REVISED RESPONSE TO REQUEST FOR ADDITIONAL INFORMATION

APR1400 Design Certification

Docket No. 52-046

RAI No.: 72-8020
SRP Section: 03.02.02 – System Quality Group Classification
Application Section: 3.2.2
Date of RAI Issue: 07/15/2015

Figure 10.4.9-1 Auxiliary Feedwater System Flow Diagram (1 of 3)

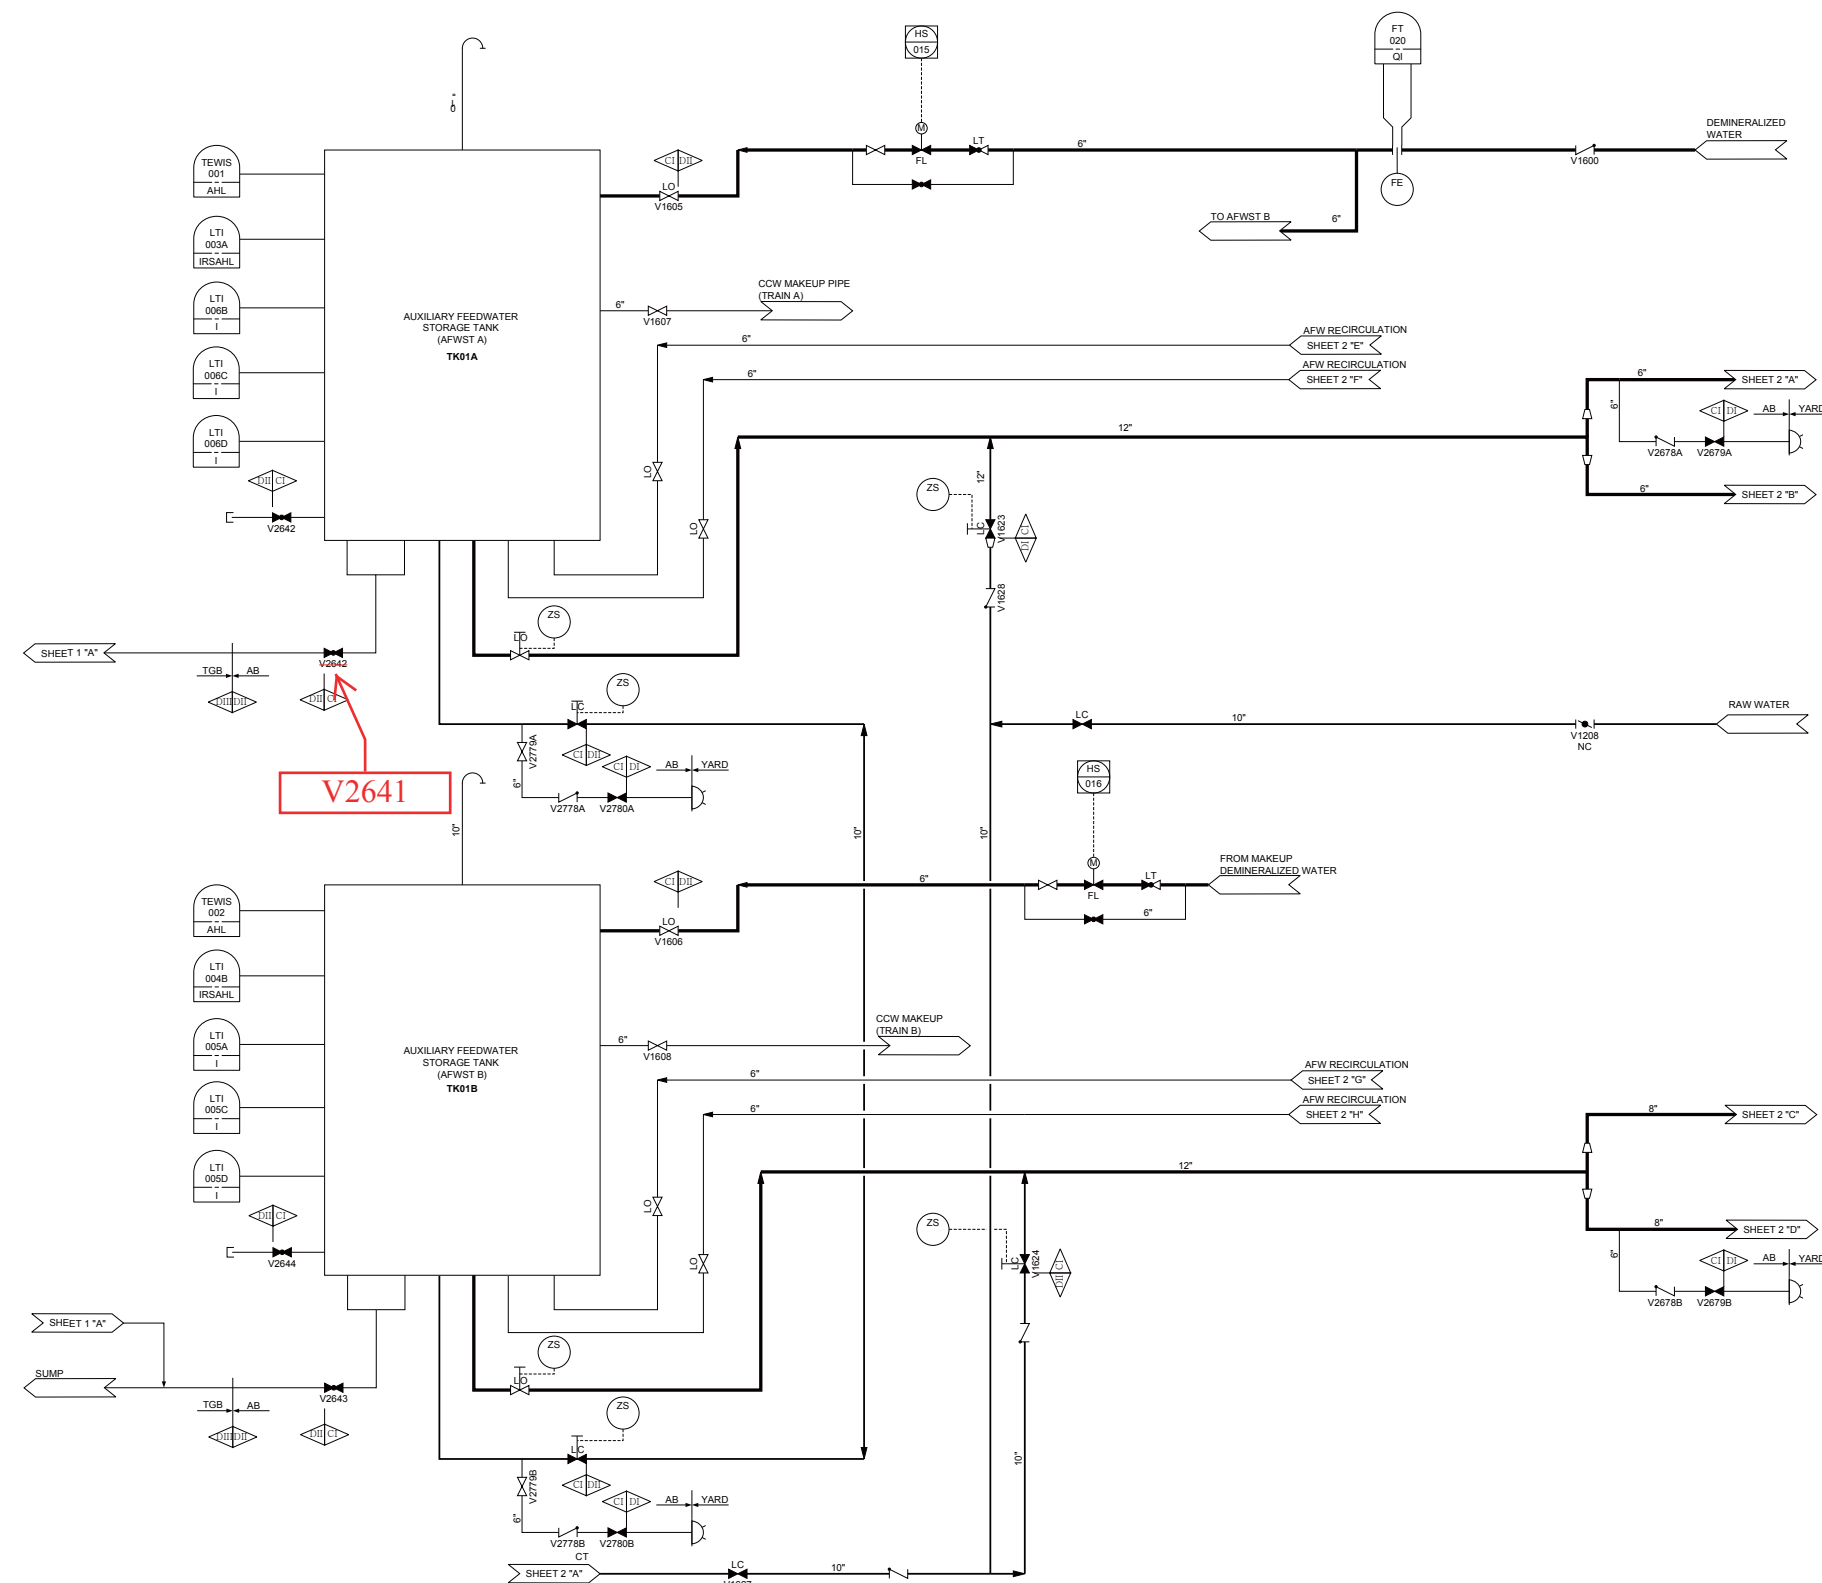
Valve V2641 is on the bottom drain line of AFWST A in Figure 10.4.9-1 (sheet 1 of 3) which erroneously had two valves designated as V2642. Figure 10.4.9-1 will be changed to correctly identify valve V2641. The valves V2012A/B in Figure 10.4.9-1 (sheet 2 of 3) are changed to V2102A/B; (refer to Attachment 2).

Figure 10.4.9-1 Auxiliary Feedwater System Flow Diagram (2 of 3)

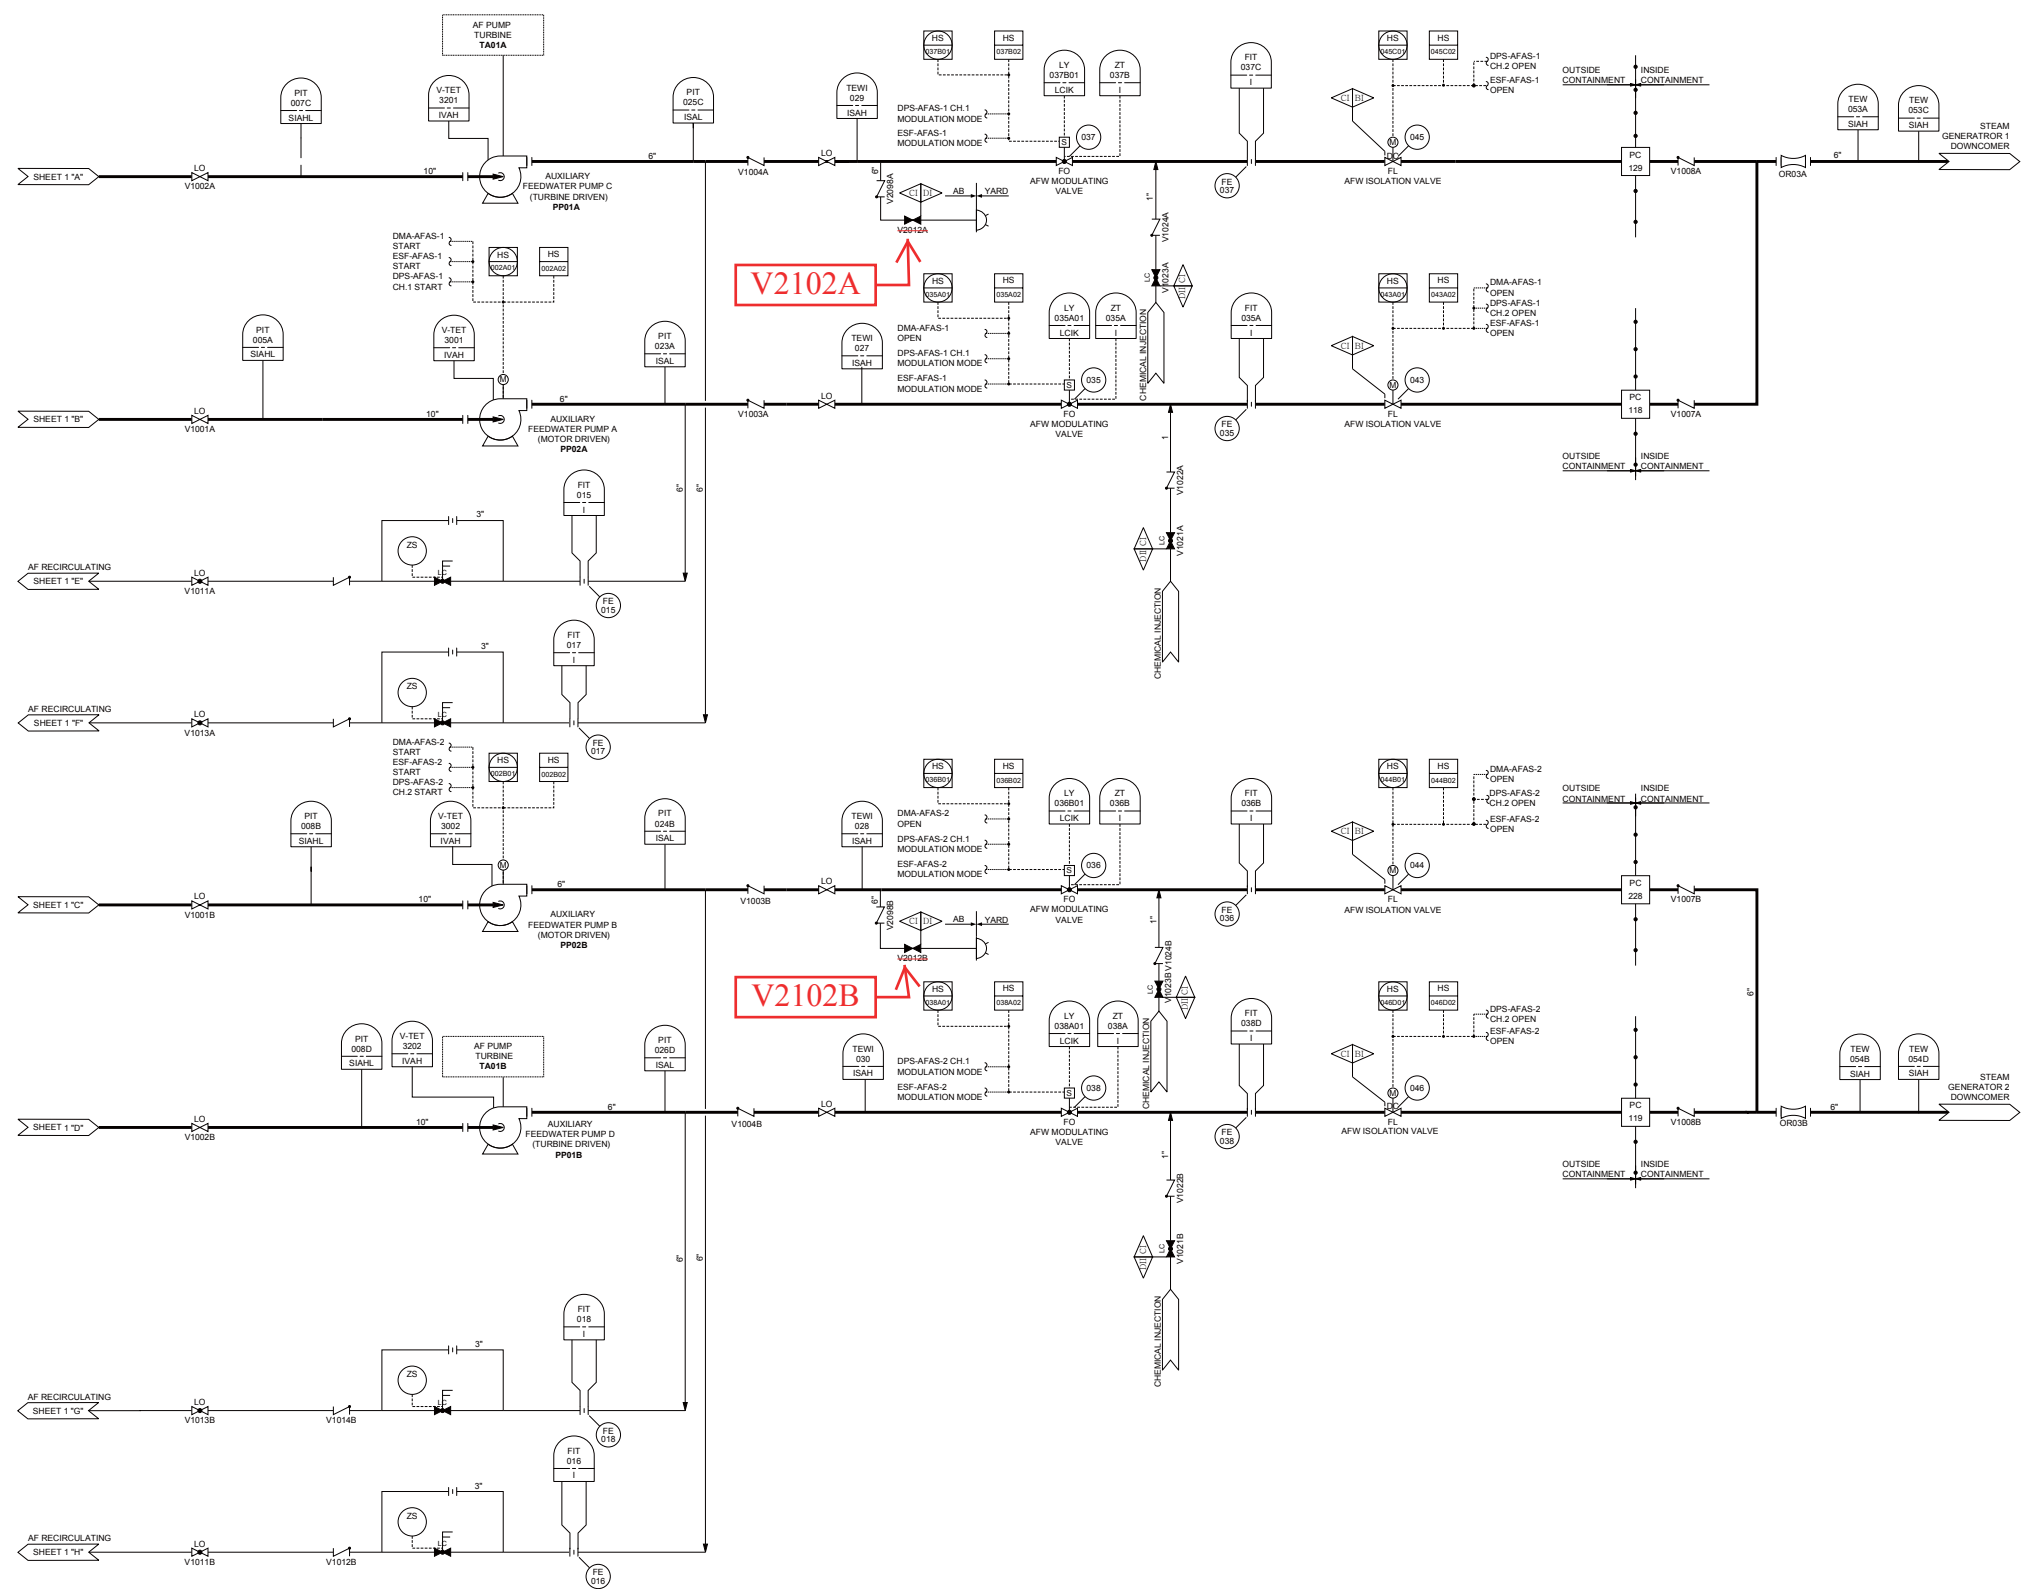
Table 3.2-1 page 2 correctly lists valves V2102A/B; however, these valves are incorrectly identified in Figure 10.4.9-1 Auxiliary Feedwater System Flow Diagram (sheet 2 of 3) as 2012A/B. Figure 10.4.9-1 will be changed to correctly identify V2102A/B; (refer to Attachment 2).

Figure 5.1.2-3 Pressurizer and POSRV Flow Diagram

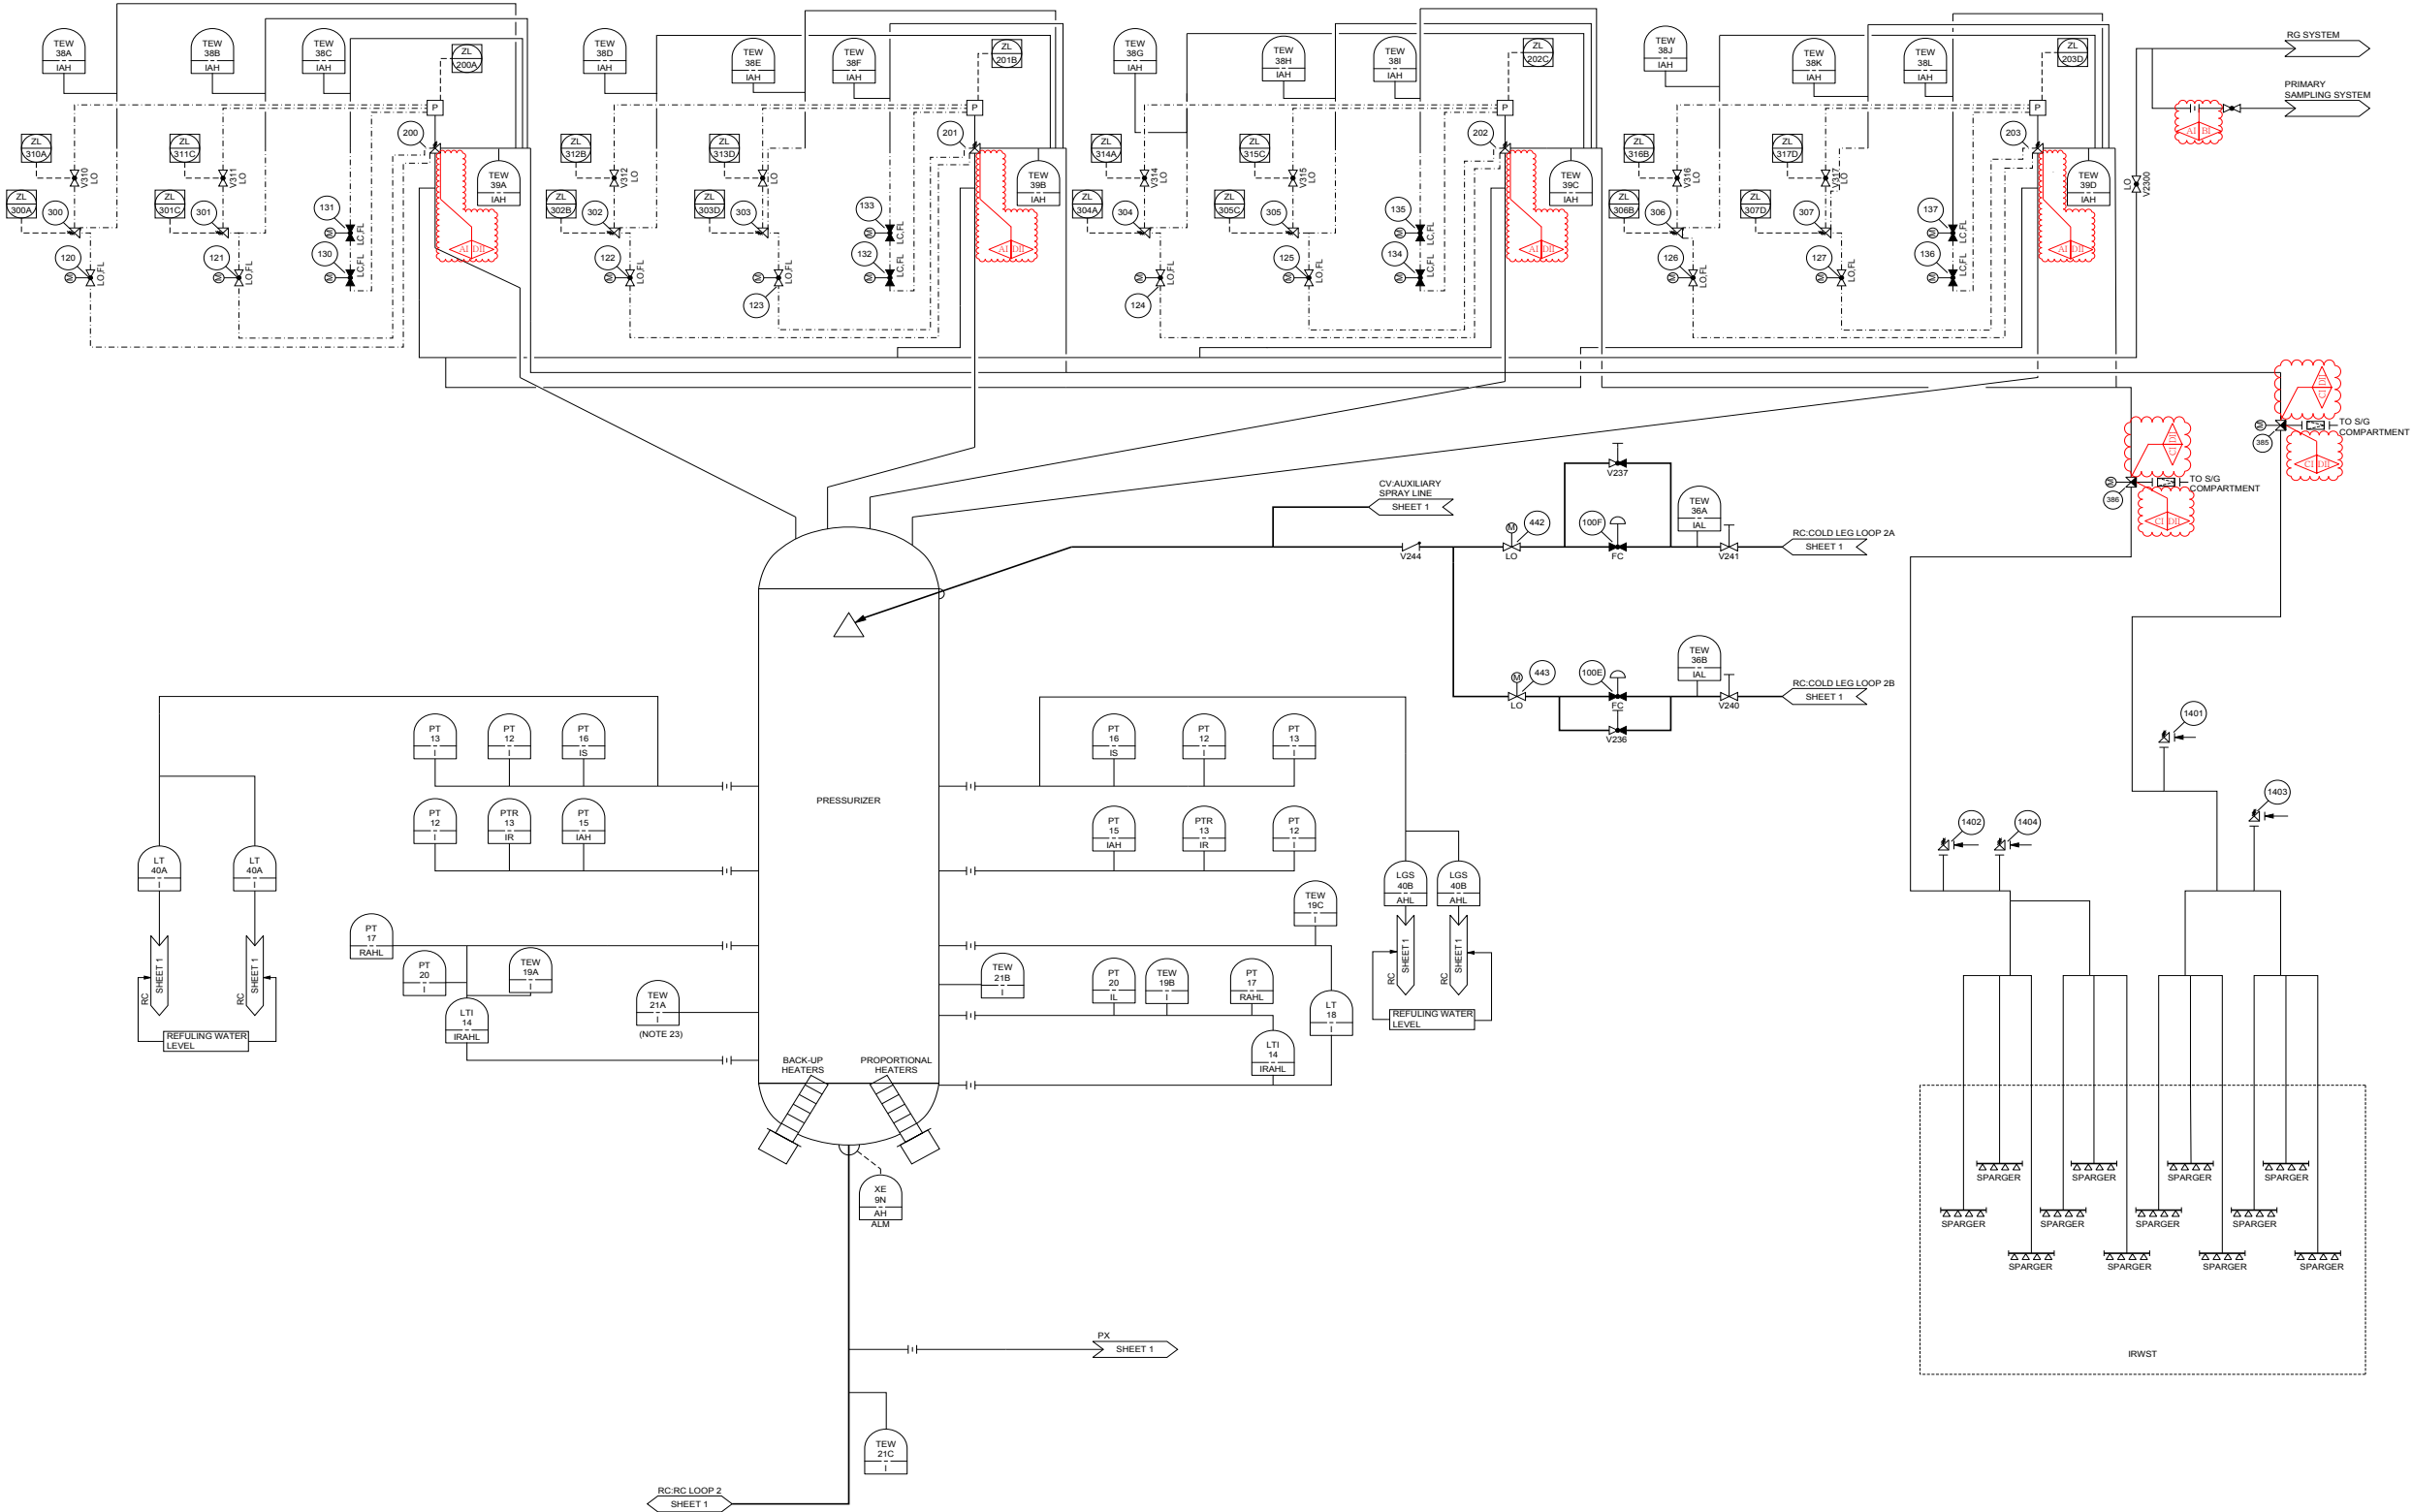
The addition of the POSRV piping in Table 3.2-1 incorrectly identified the upstream and downstream sides of the 3-way valves and will be reversed. Also, the piping class break at the POSRV is incorporated into Figure 5.1.2-3 Pressurizer and POSRV Flow Diagram; (refer to Attachment 1 page 68 and Attachment 3).
